**Re: Type B Water License #2BB-MRY0710
Mary River Project
Part J, Item 1 – Modification to Waste Disposal Facilities
Request for Board Approval**

Through this submission, Baffinland formally requests of the Board approval for a modification to the existing Waste Disposal Facilities at Milne Inlet and Mary River camps under Part J, Item 1 of 2BB-MRY0710. Baffinland proposes to increase temporary pond capacity through the provision of an additional two-cell pond at the Mary River camp and a single cell pond at the Milne Inlet camp. Design of this lined pond space is provided on attached drawings C701, C702, C801 and C802 stamped by a Professional Engineer licensed to practice in Nunavut.

MARY RIVER
PWSP #2
PLAN/PROFILE

Project
MILNE INLET PROJECT
BAFFIN LAND IRON
MINES CORP
BAFFIN ISLAND NUNAVUT
Drawing
MILNE INLET
PWSP #2
PLAN/PROFILE

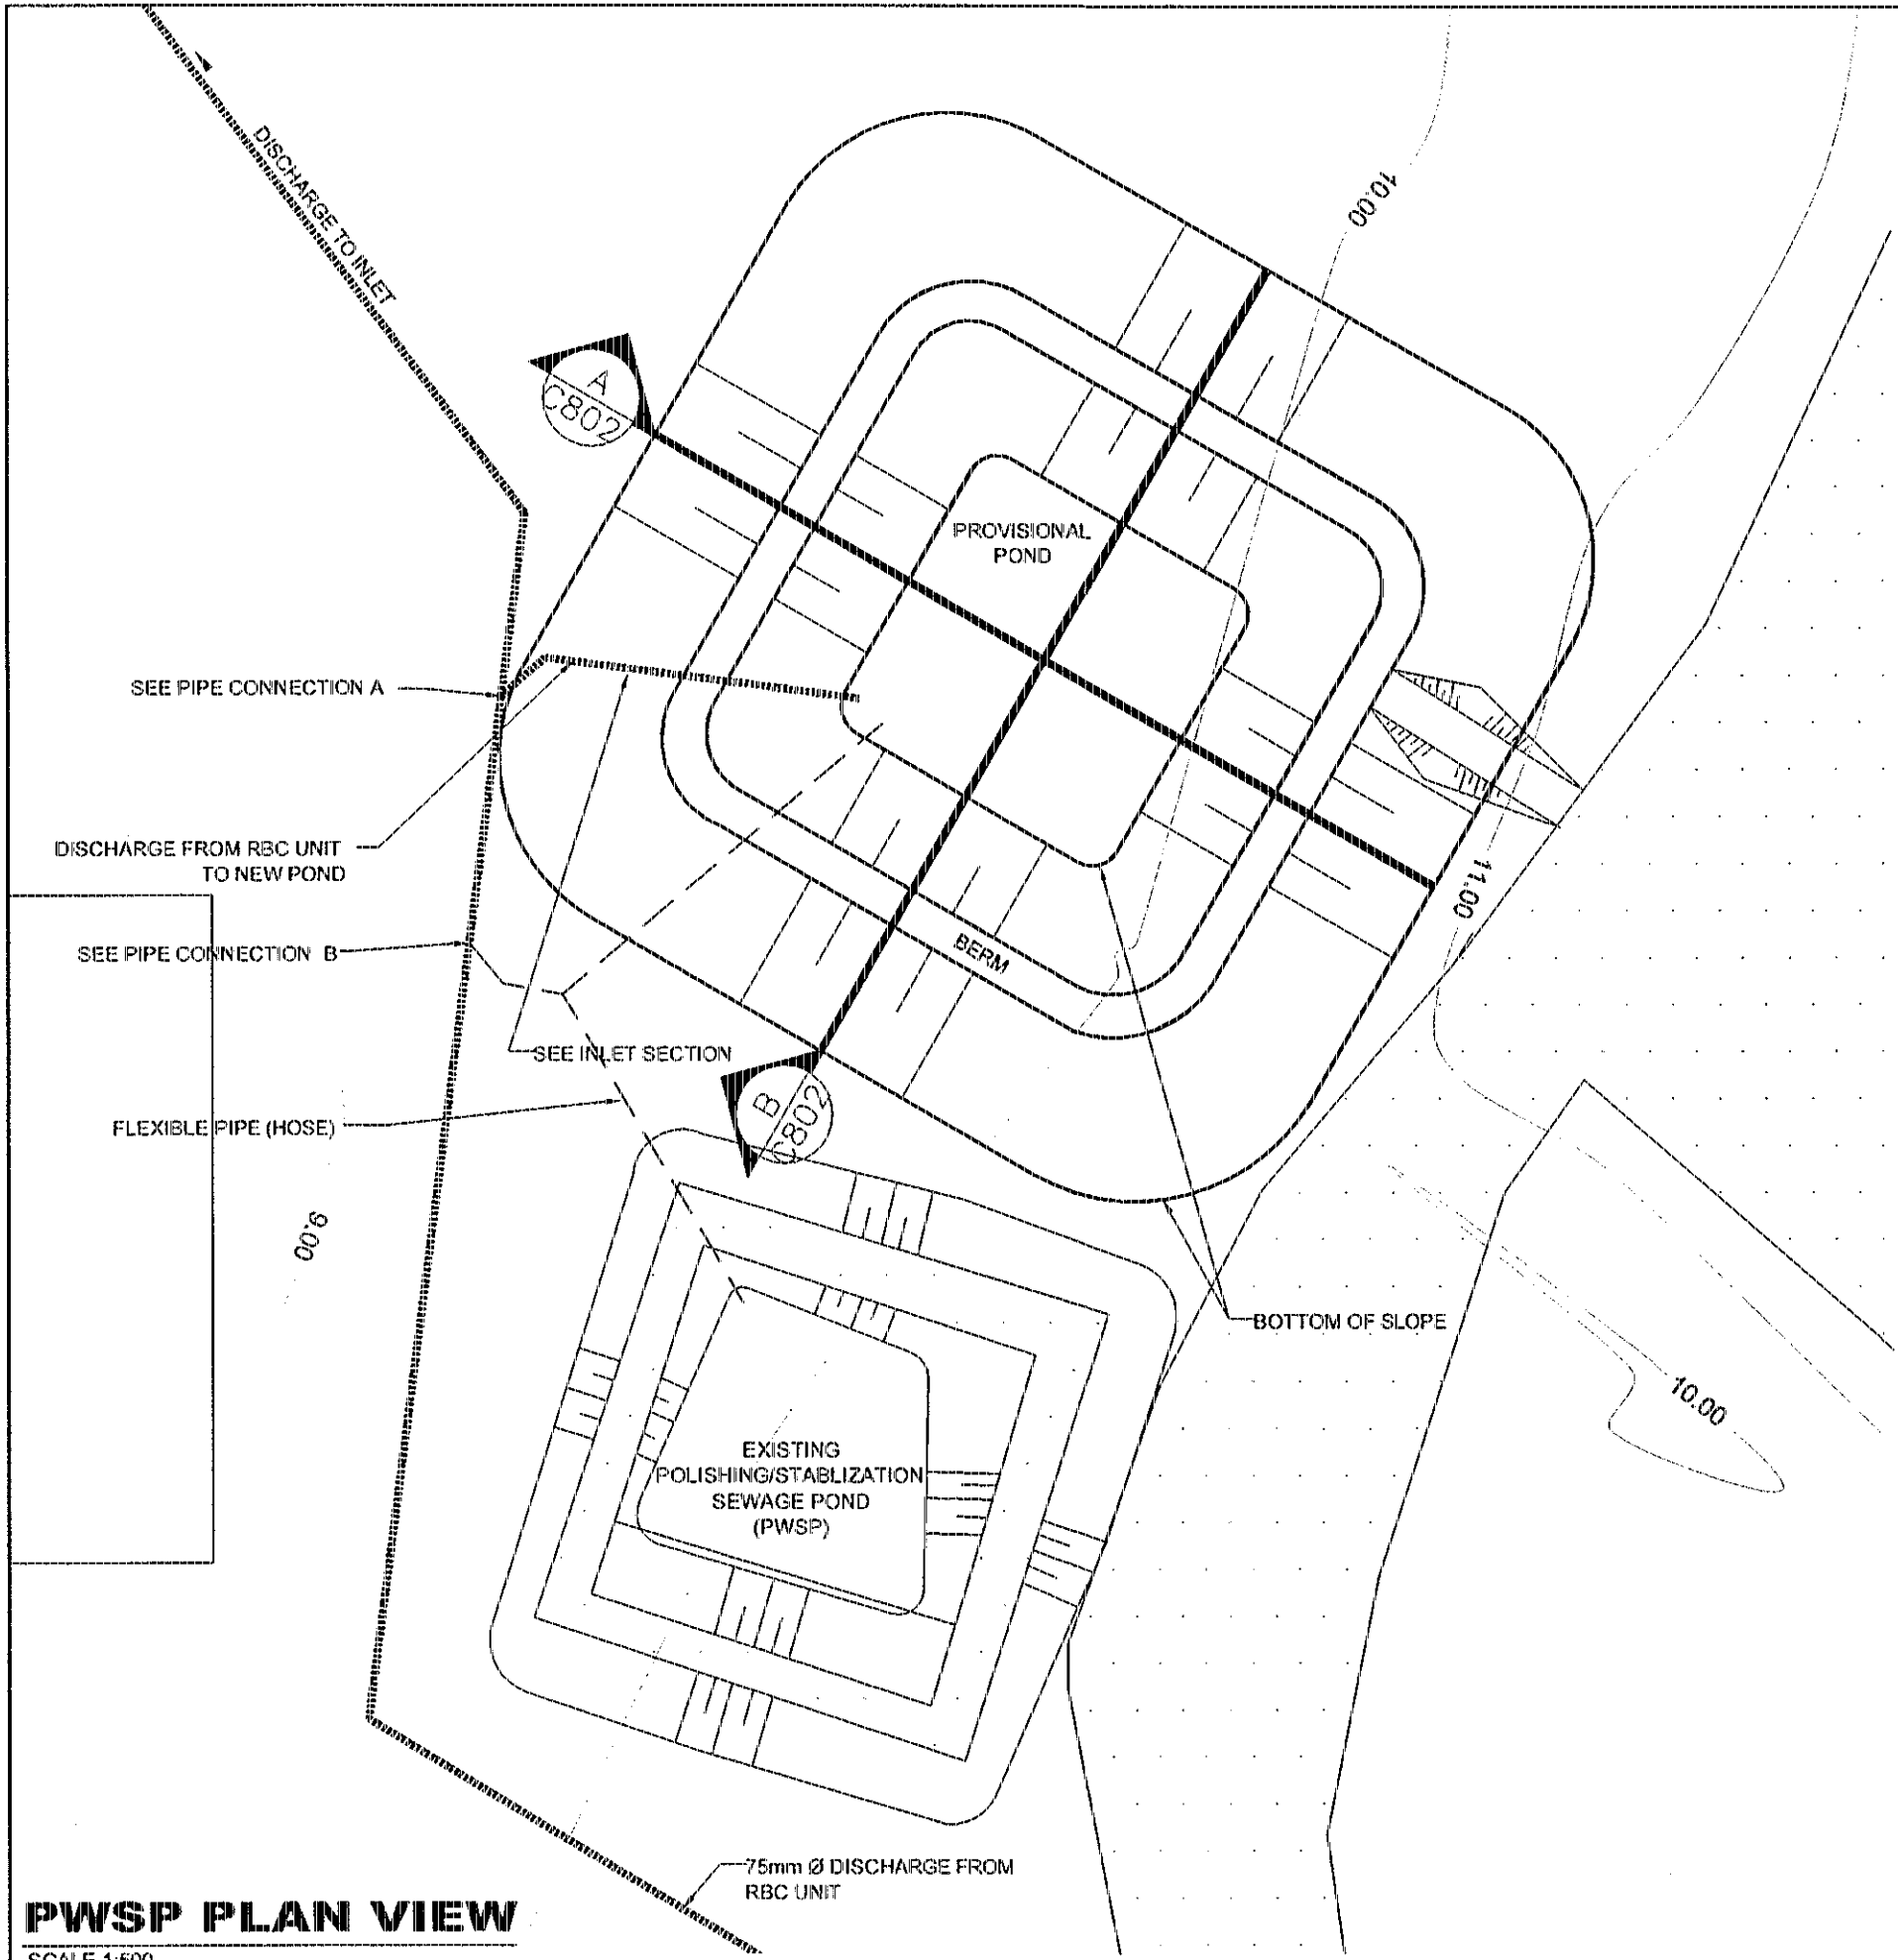
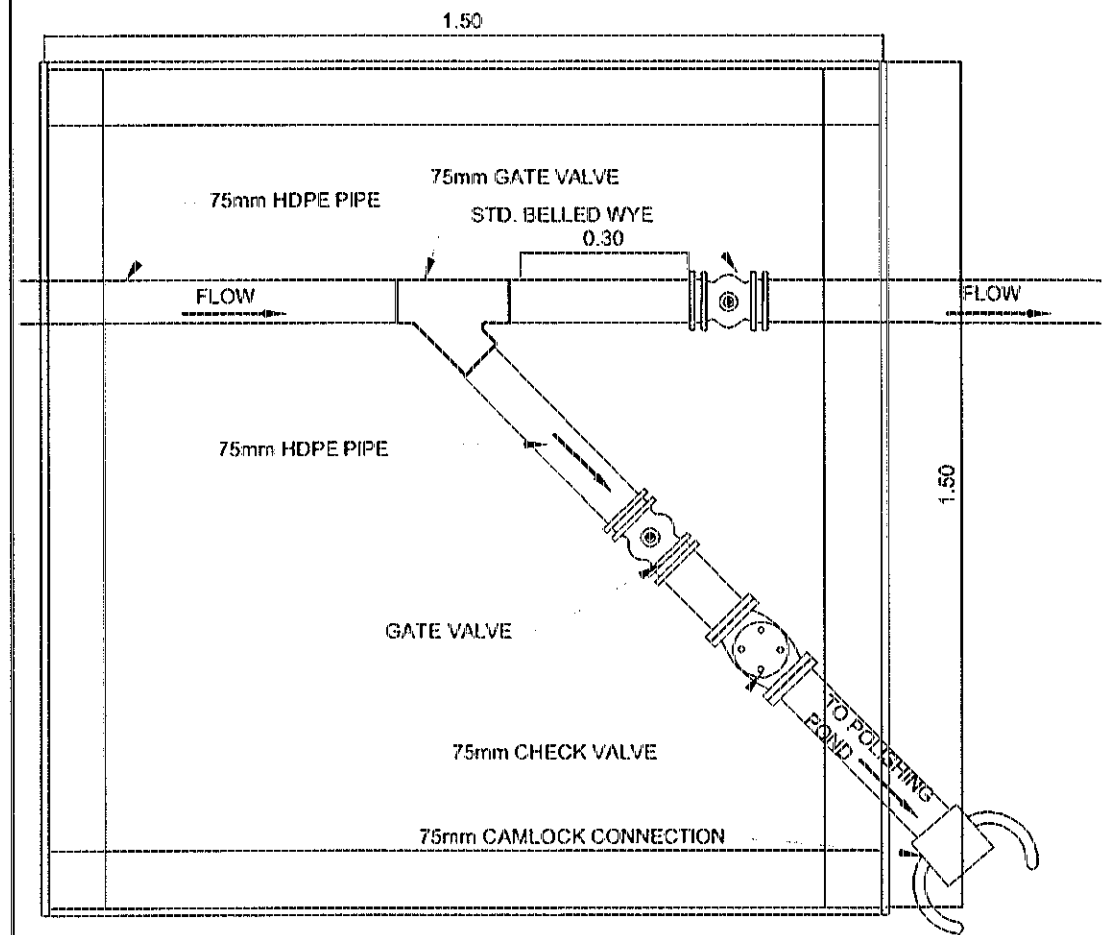
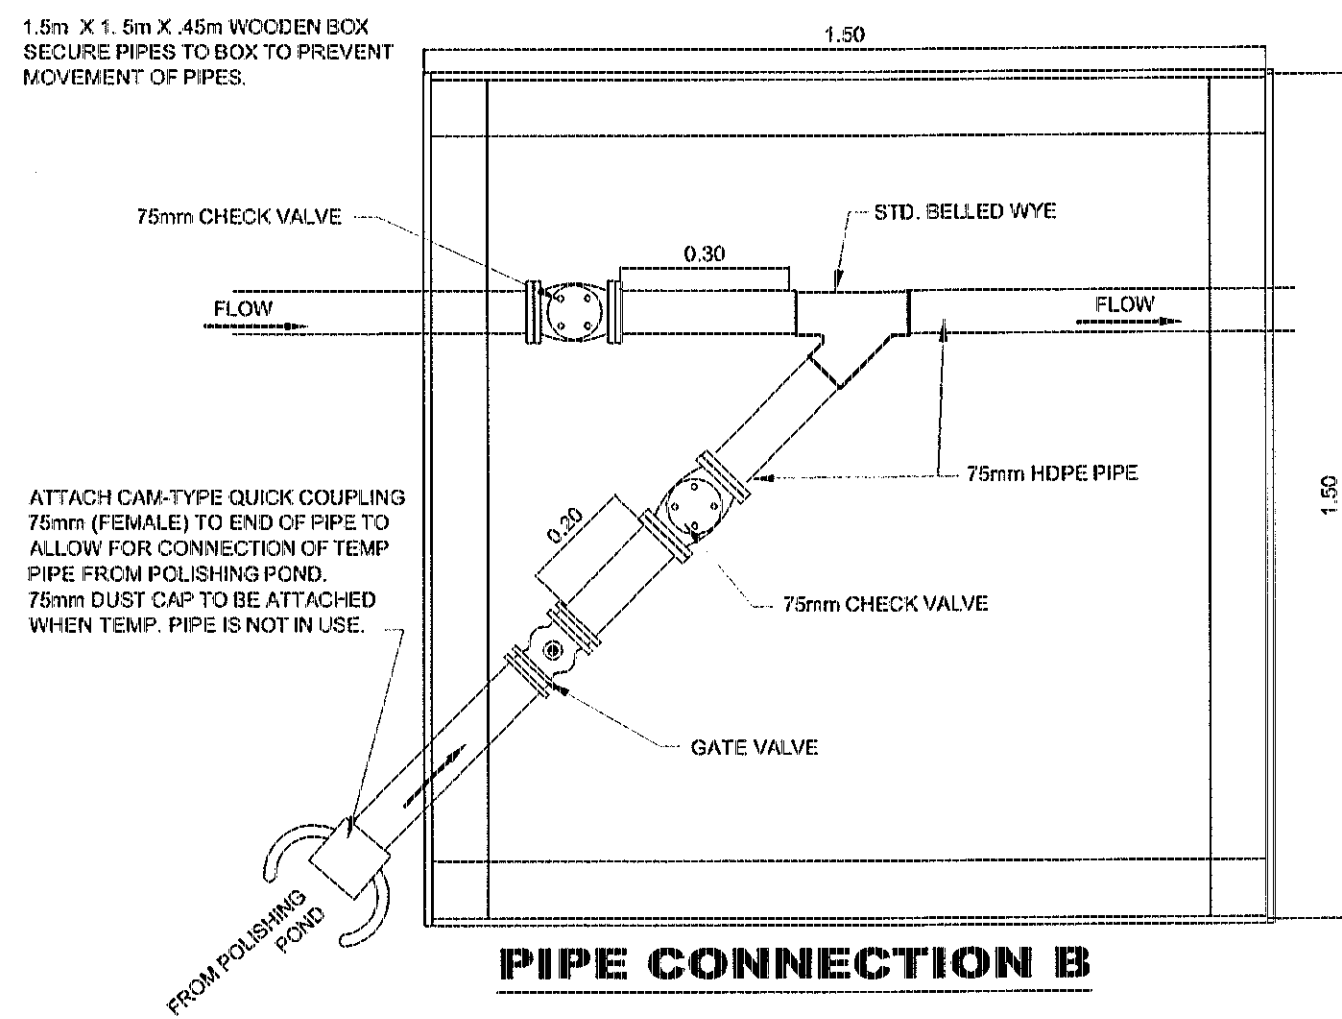
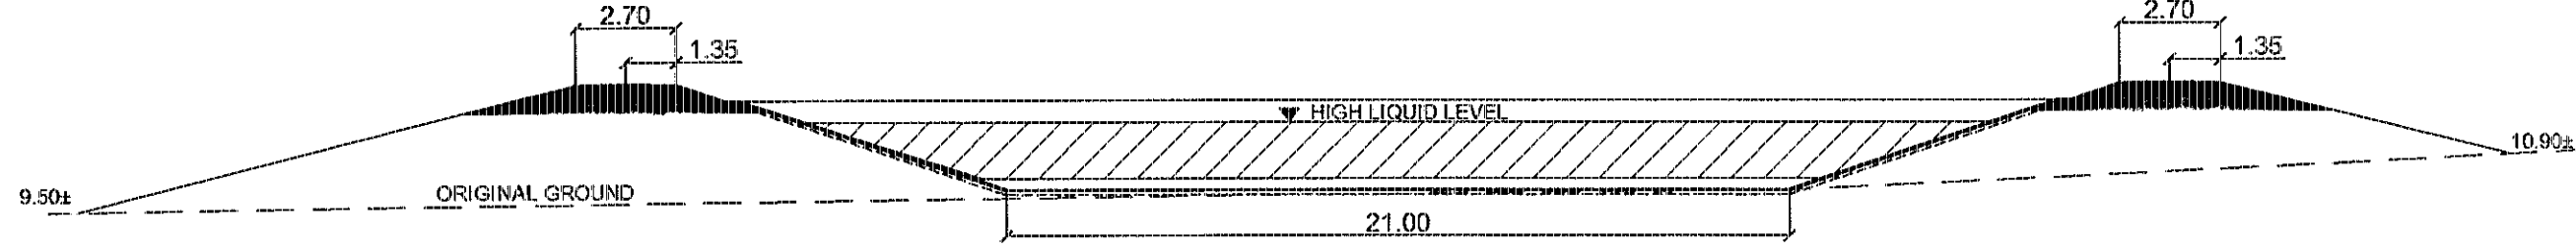
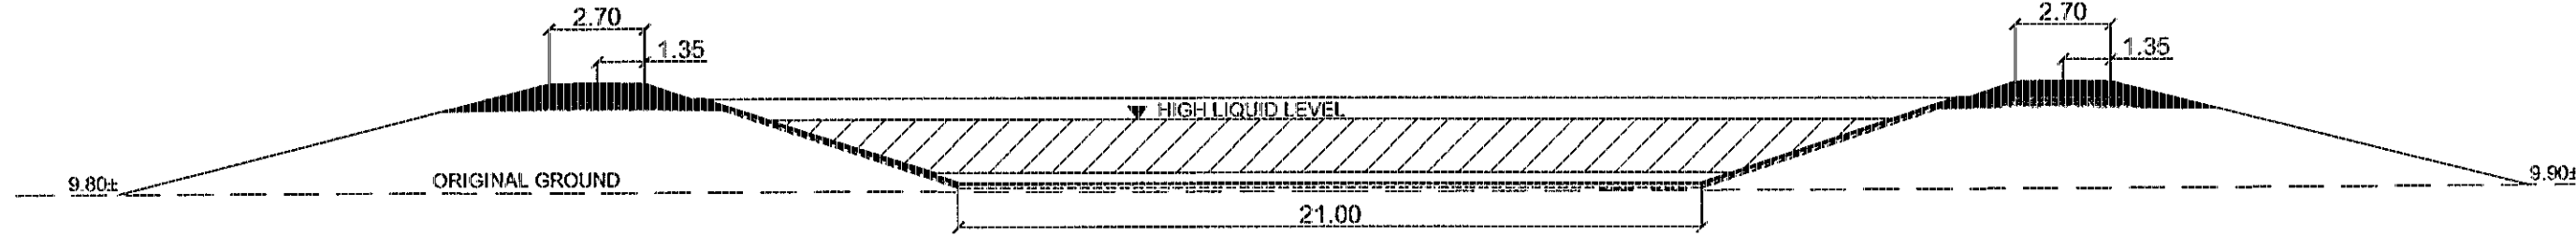
The 2nd cell at the Mary River camp and the single pond cell at the Milne camp are intended to provide further contingency in the event that pond space is not available to accept treated effluent during on-going operations due to system upsets during which average effluent requirements may not be consistently met. These ponds are identified as further contingency and may not be required depending on realized performance of the rotating biological contactors. However, Baffinland seeks approval to construct these ponds in the event they are indeed required.
